PROJECT TITLE:
GARDEN HILL FIRST NATION +
WASAGAMACK FIRST NATION
HOUSING PROJECT
STREET NAME AND NUMBER
CITY, PROVINCE, POSTAL CODE

DRAWING TITLE:
FLOOR PLAN

A-1
SHEET 1 OUT OF 06

4 WEST ELEVATION
 SCALE: 1/4" = 1'-0"

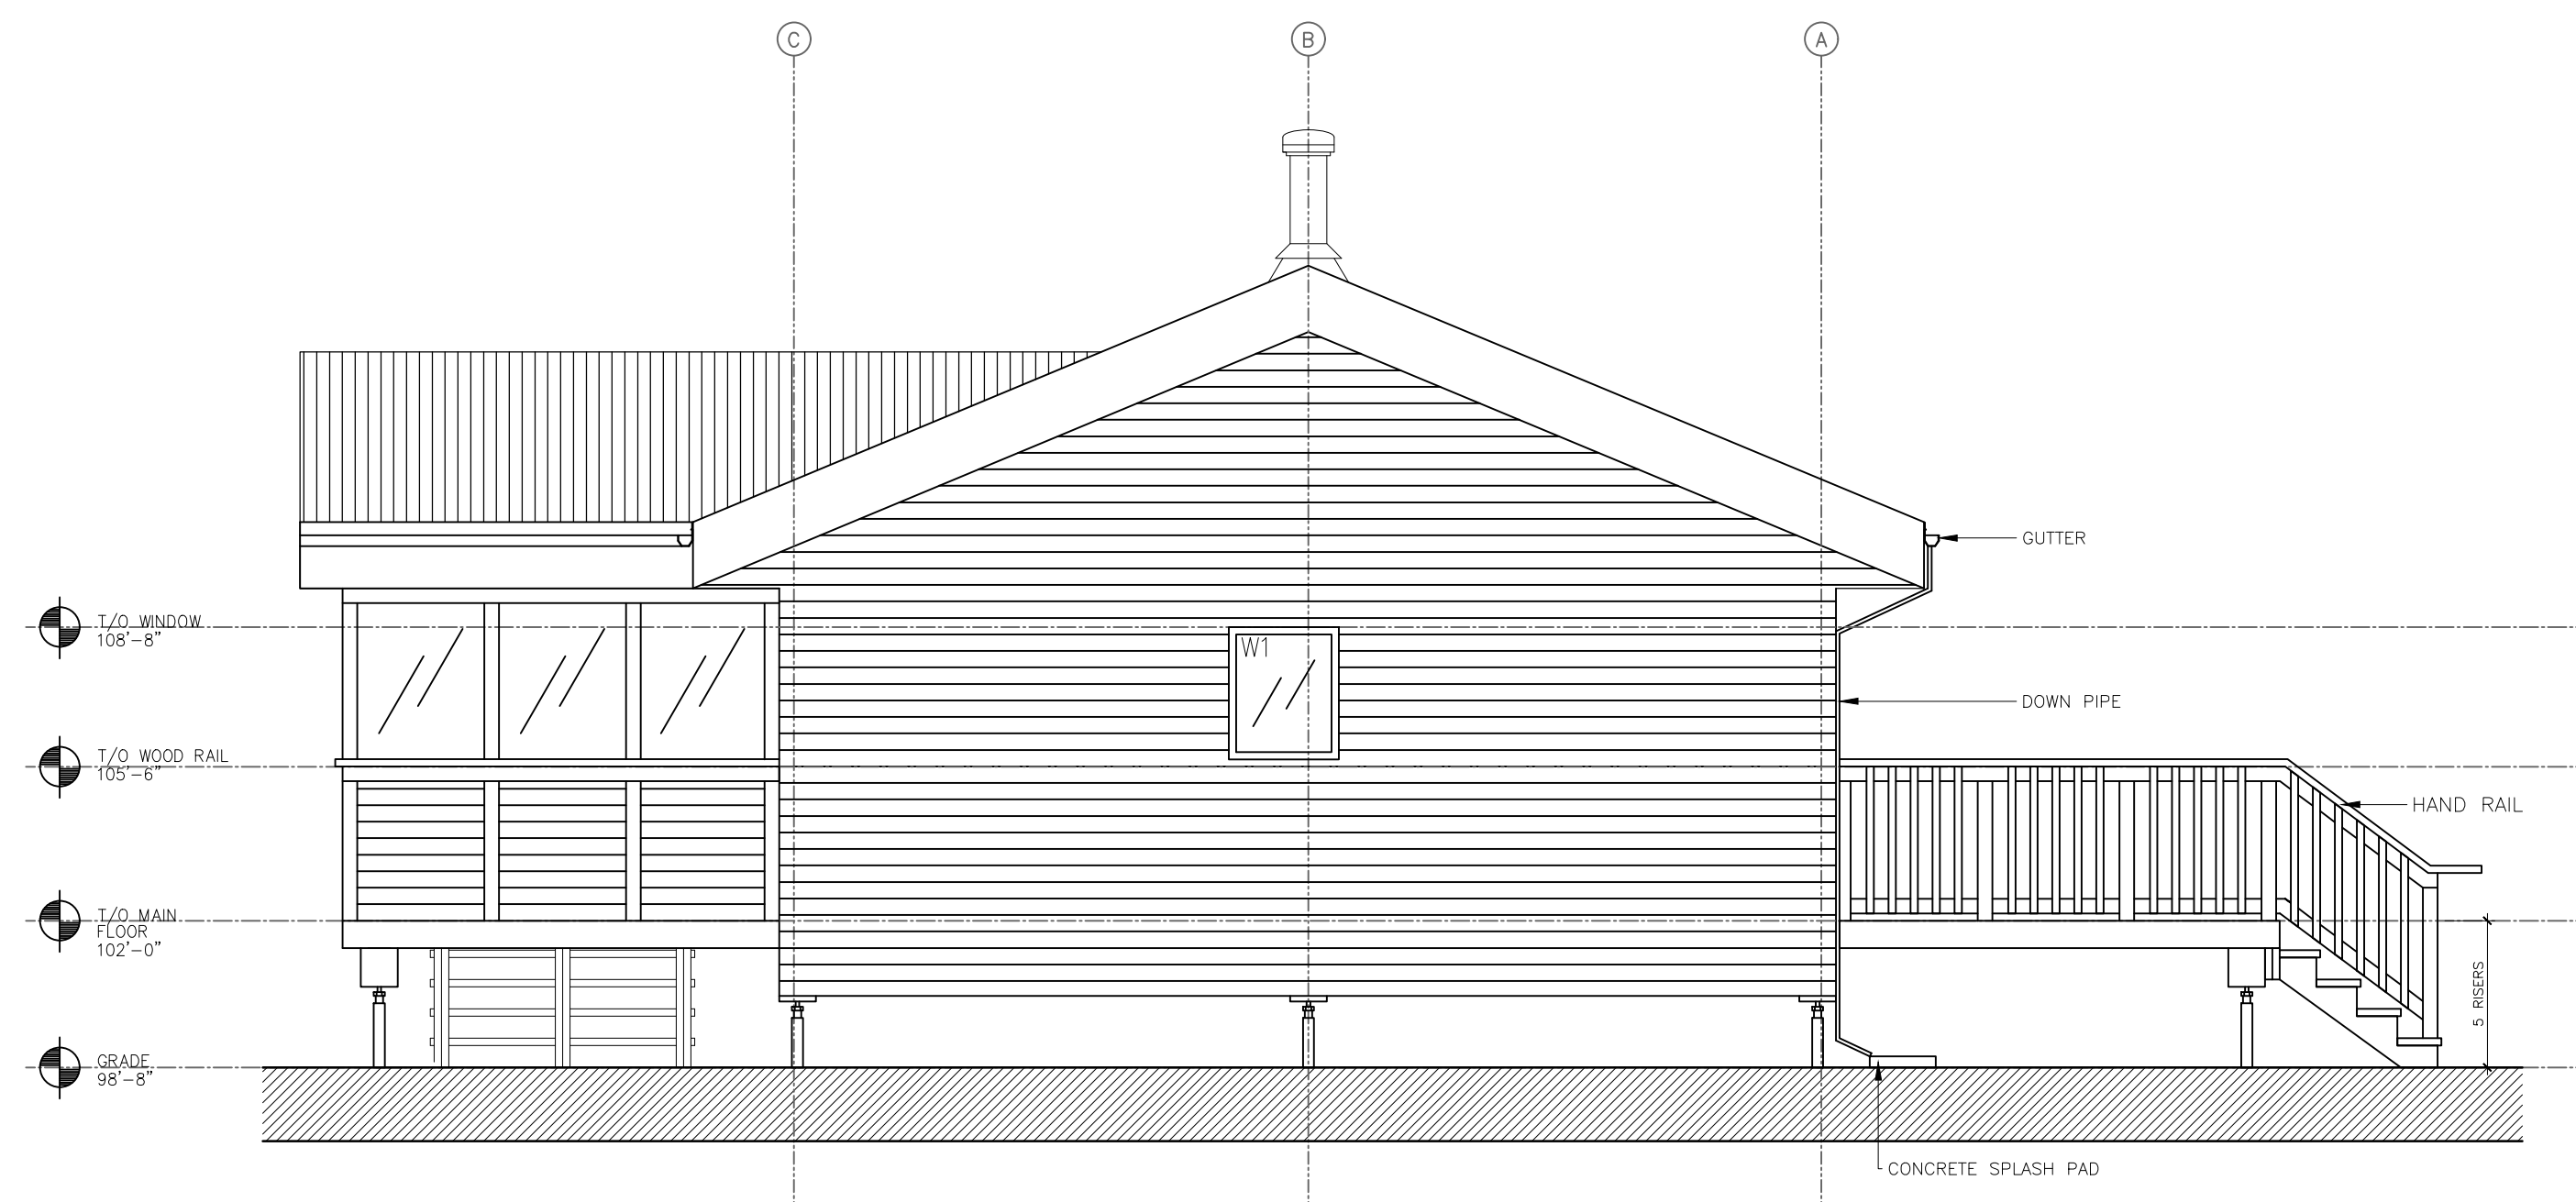
CONCERNS FOR REVIEW:
 1. CONSTRUCTION OF ENCLOSED VERTICAL CHASE
 I.1. ON PACKED GRAVEL?
 I.2. HOW TO INSULATE?
 2. STRUCTURAL LOAD CALCULATION MUST BE DONE. ADJUSTMENTS SHOULD BE MADE.
 3. ROOF AND CEILING ASSEMBLY.
 4. CHIMNEY AND MASONRY INTERIOR WALLS HAVE NOTE BEEN DETAILED.
 4.1. PLEASE TAKE A LOOK AND DETAIL AS APPROPRIATE.

A-3
 SHEET 3 OUT OF 06

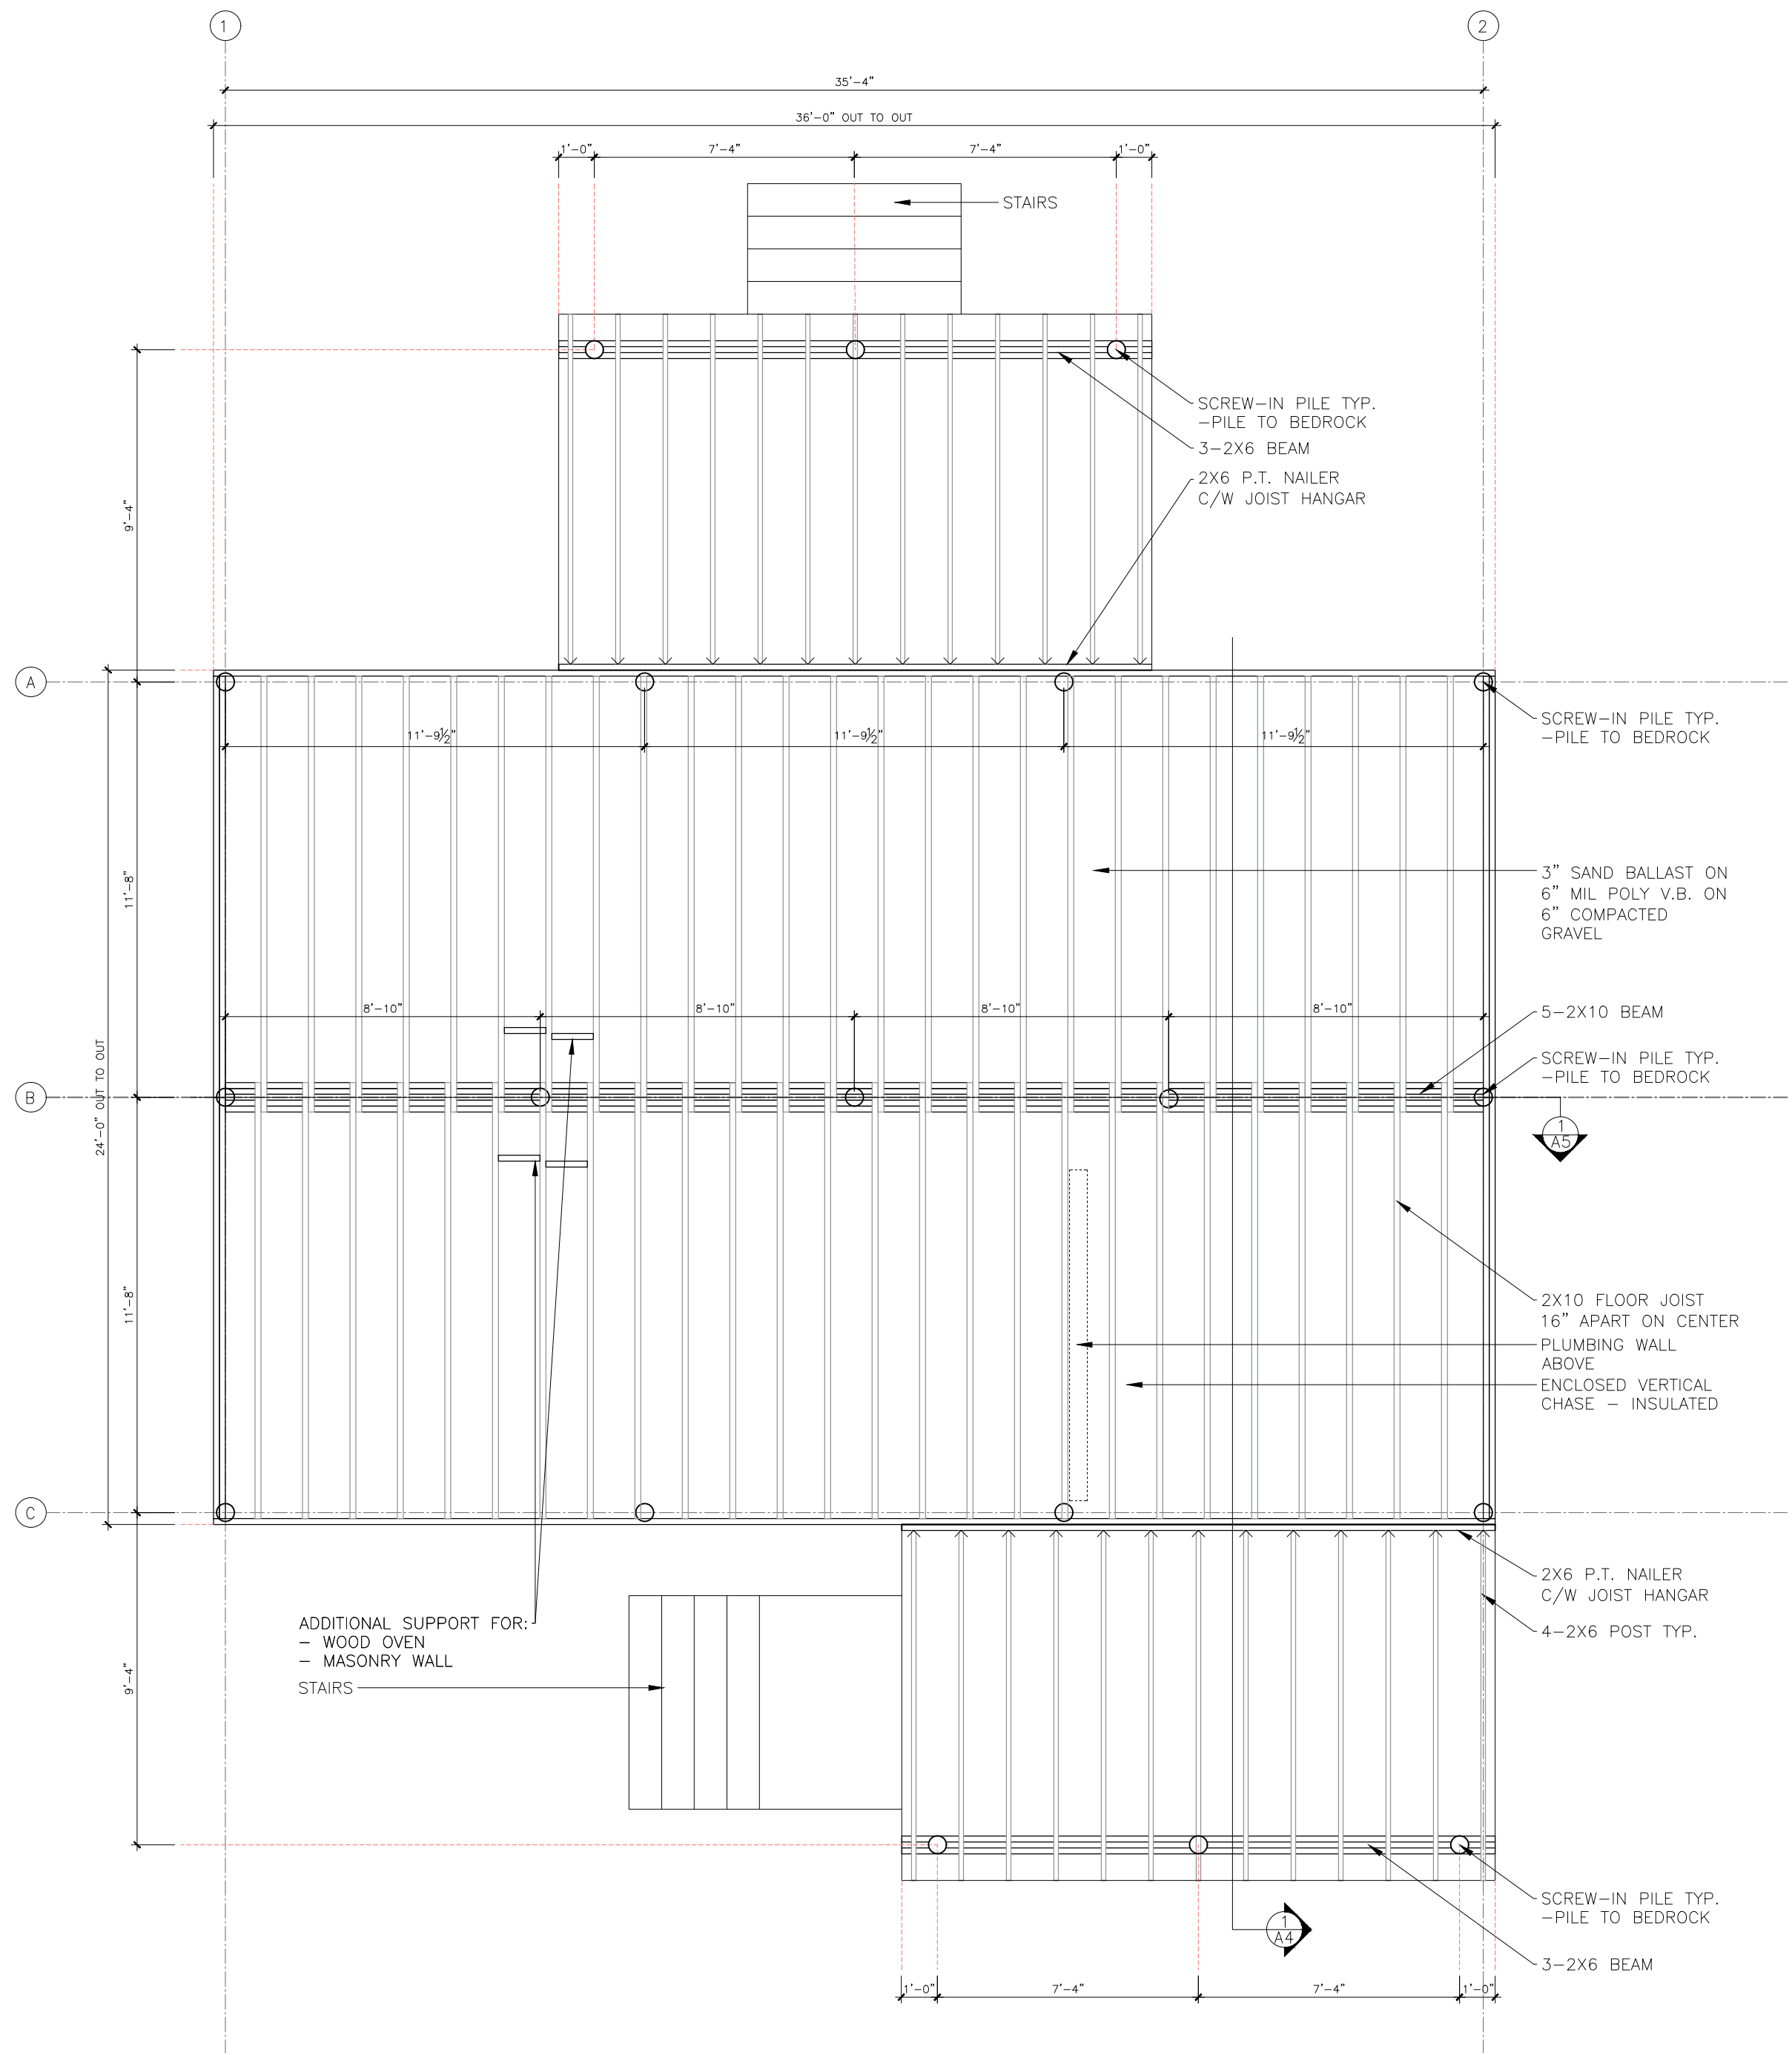
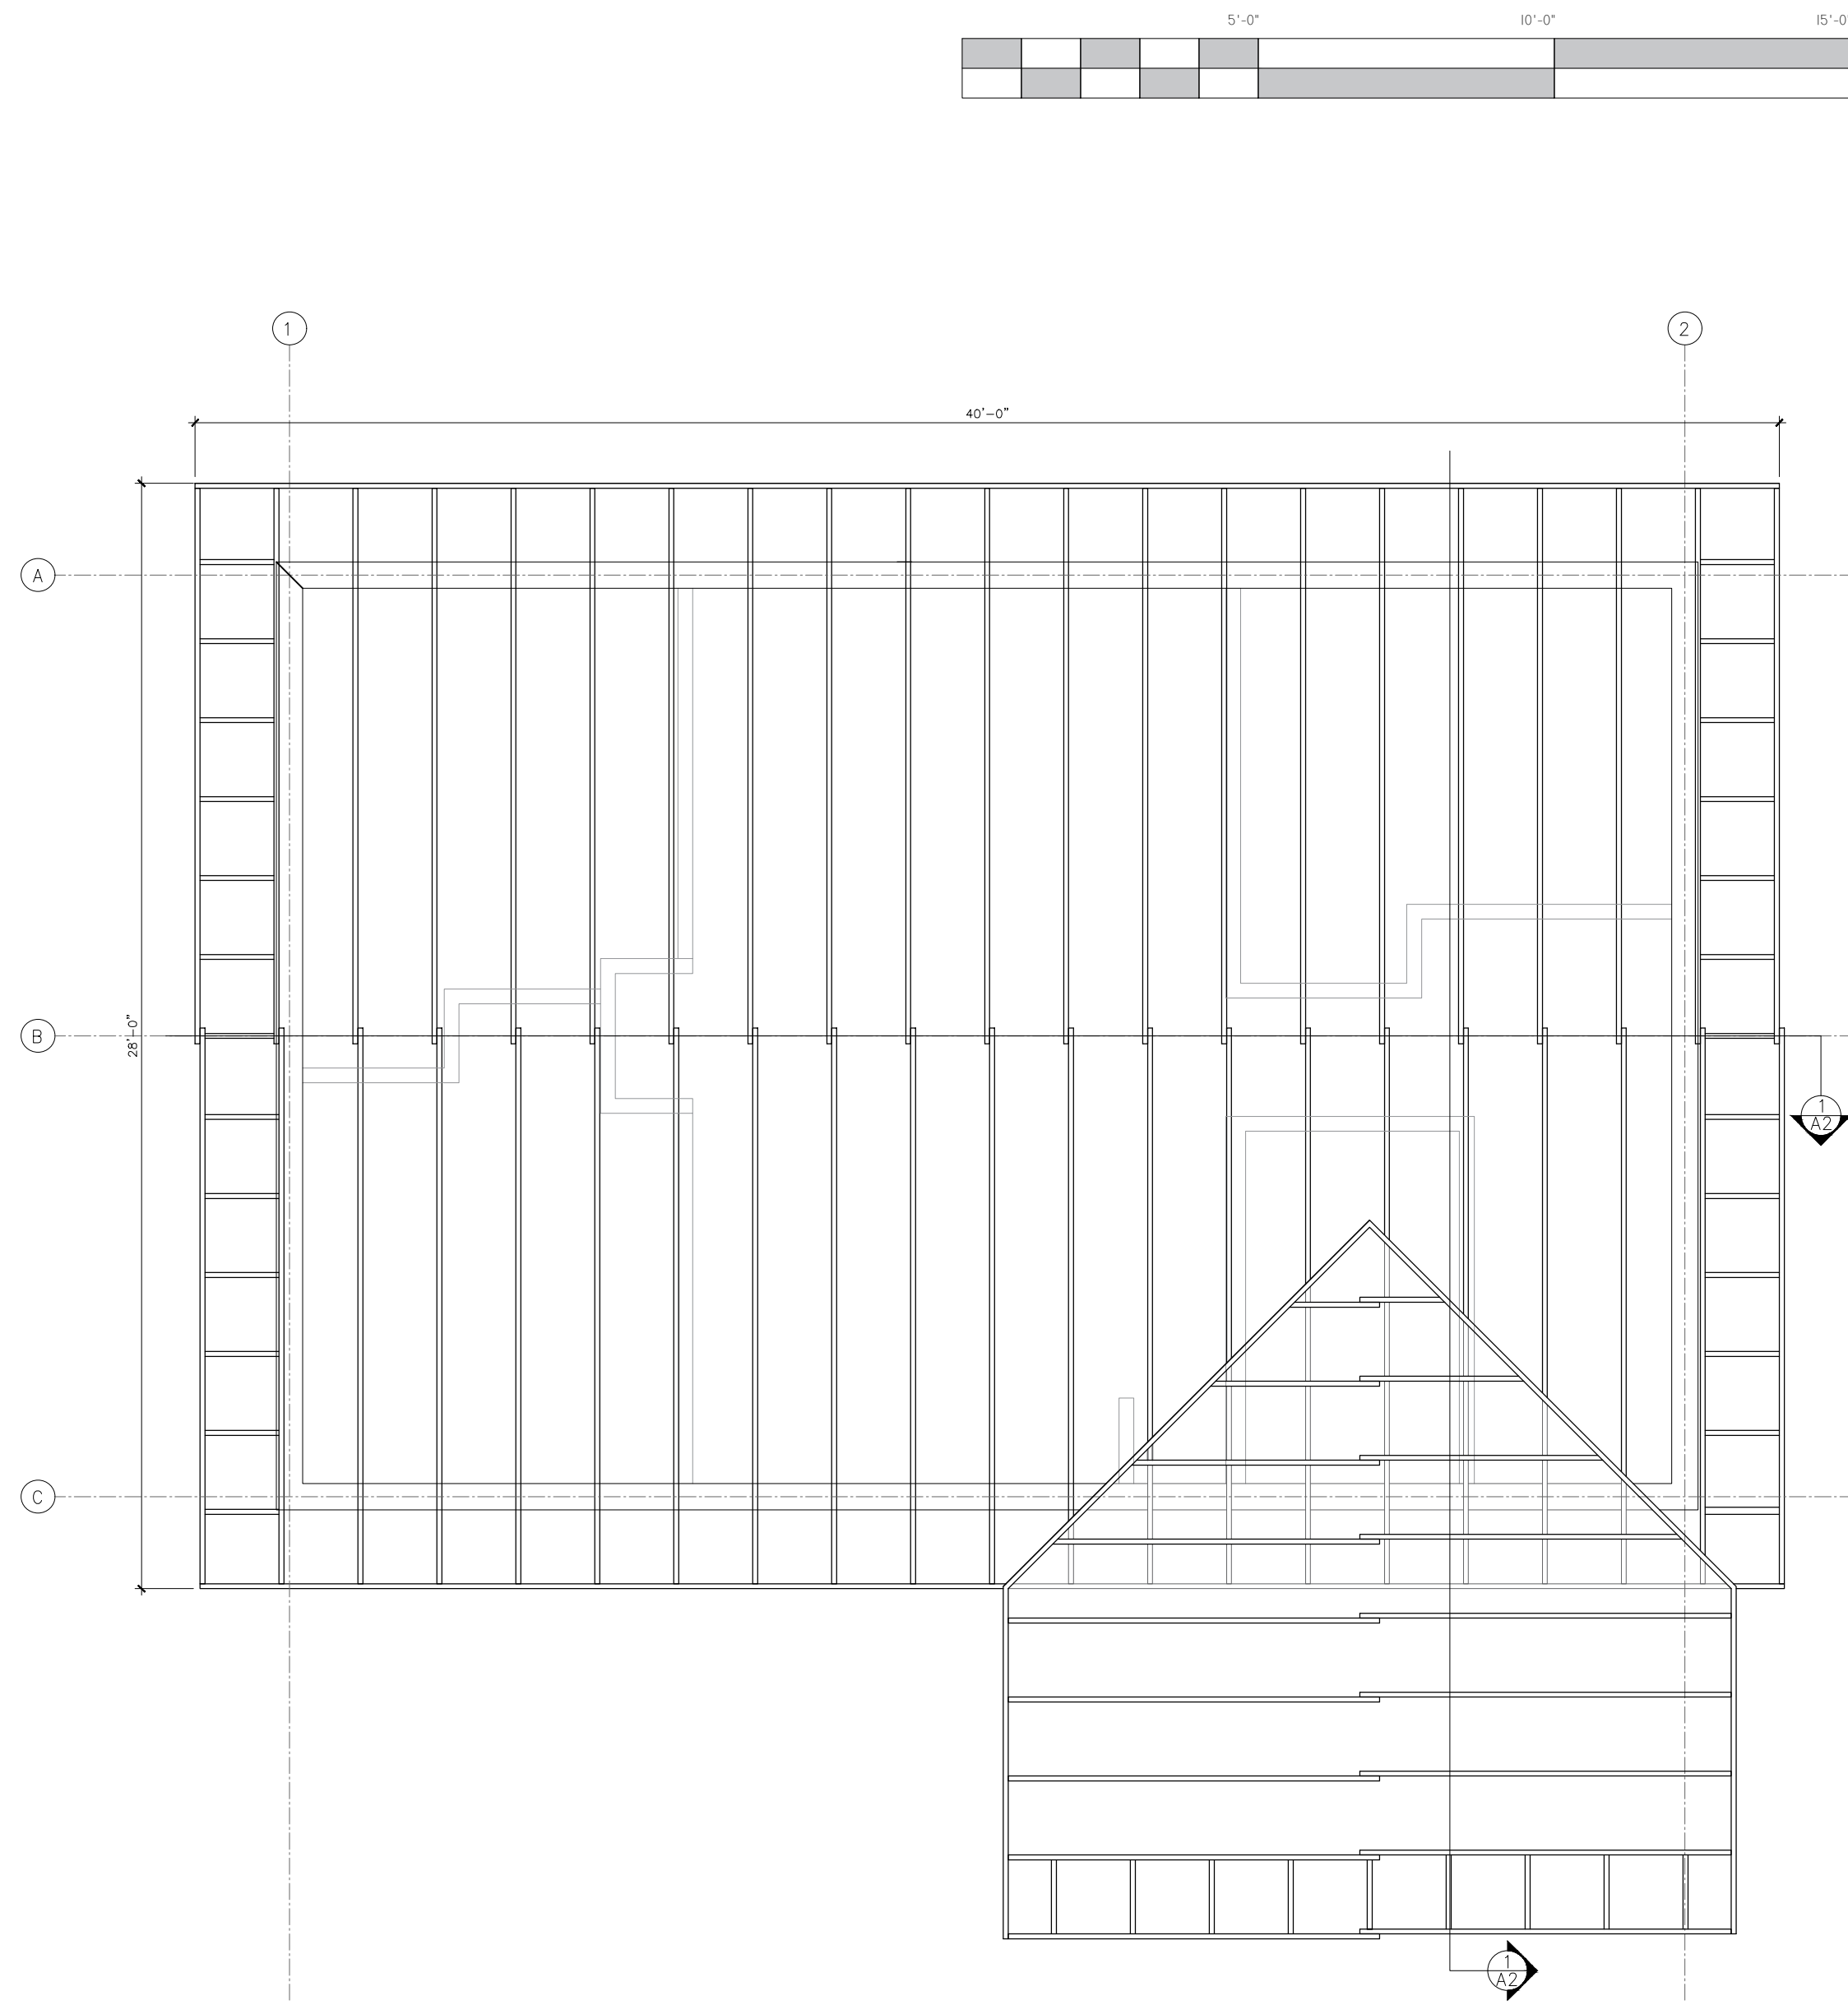
CONCERNS FOR REVIEW:
 1. CONSTRUCTION OF ENCLOSED VERTICAL CHASE
 I.1. ON PACKED GRAVEL?
 I.2. HOW TO INSULATE?
 2. STRUCTURAL LOAD CALCULATION MUST BE DONE. ADJUSTMENTS SHOULD BE MADE.
 3. ROOF AND CEILING ASSEMBLY.
 4. CHIMNEY AND MASONRY INTERIOR WALLS HAVE NOTE BEEN DETAILED.
 4.1. PLEASE TAKE A LOOK AND DETAIL AS APPROPRIATE.
